July 26, 2010

**Re: Construction Storm Water Inspection at Whitehall Defense Supply Center-
DSCC/Franklin County.
Permit Number: 4GC02866*AG**

Figure 1: Silt fence will require maintenance

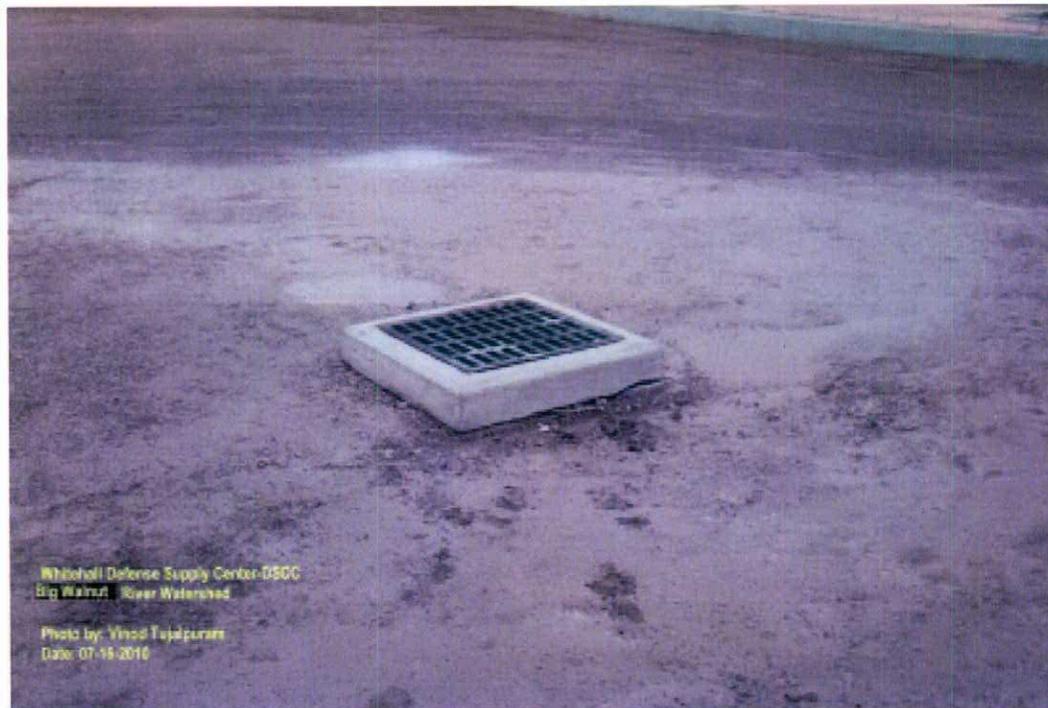
- All disturbed areas must be protected with silt fence or an appropriate alternative to address sediment and erosion controls (Figure 1).
- Please ensure all inlet protections are covered appropriately to meet the requirements of your General Storm Water Permit (Figure 2).
